Technical product information

Topic	GTC - Rattle in rear of cabin - convertible roof
Market area	Worldwide Bentley (1WBE)
Brand	Bentley
Transaction No.	2031919/1
Level	EH
Status	Approval
Release date

Continental GTC

Figure 1

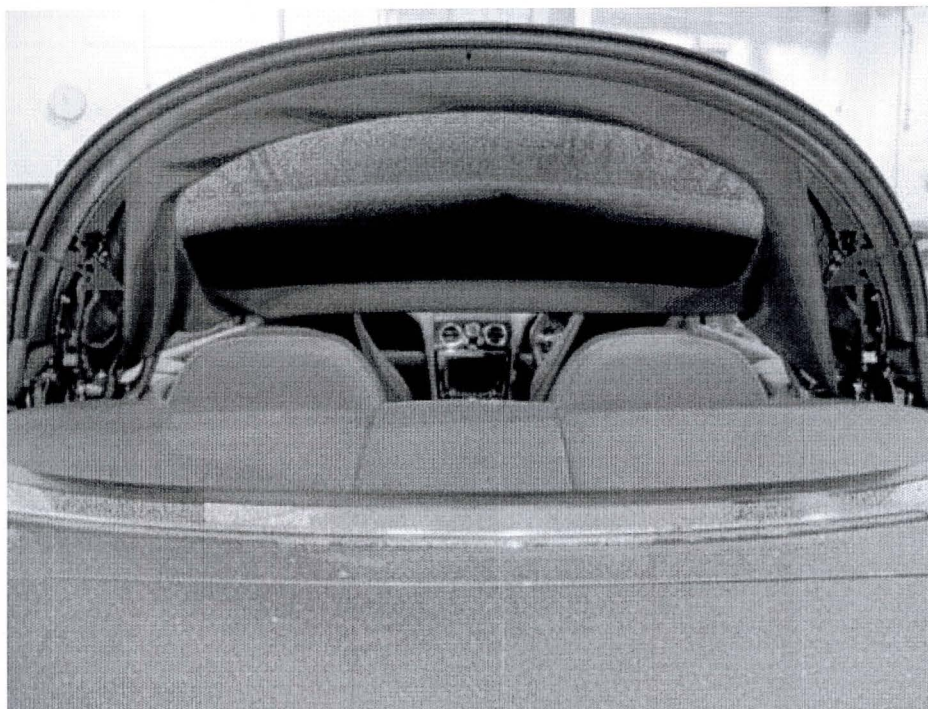
Two terminals located one each side of the heated rear screen can produce a high frequency rattle. On this occurrence the following procedure should be performed. (see Figure 1)

1. With the ignition on, use the power operated roof open and close buttons to position the roof partially open. Figure 1 shows the optimum position to enable this procedure to be performed. It is recommended that the roof position is maintained primarily with the ignition still on, and secured, for the operators safety, using a pair of tensioning straps (T10038) linked together.

Figure 2

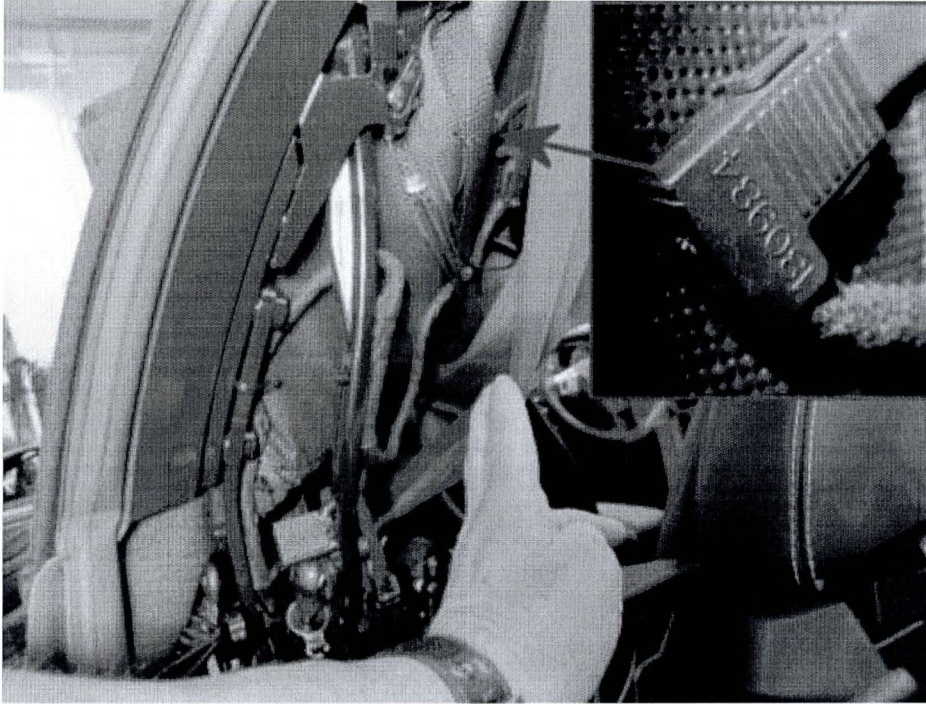
2. Referencing figure 1 and 2 locate the heated rear screen electrical connections

Figure 3

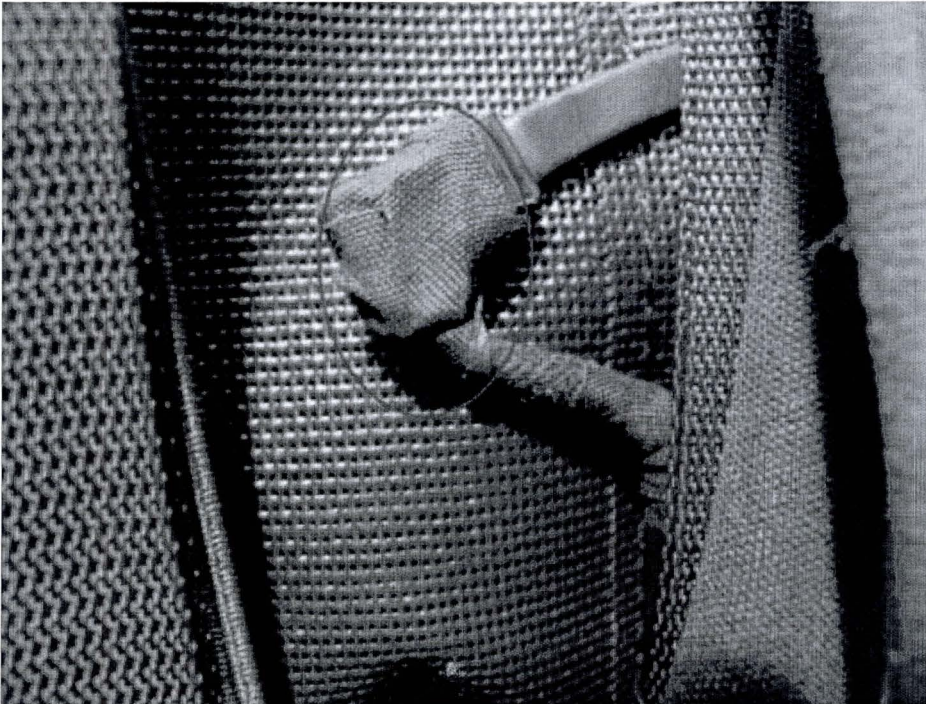
3. Wrap the terminal housing and extend the insulation tape down onto the harness (see Figure 3)
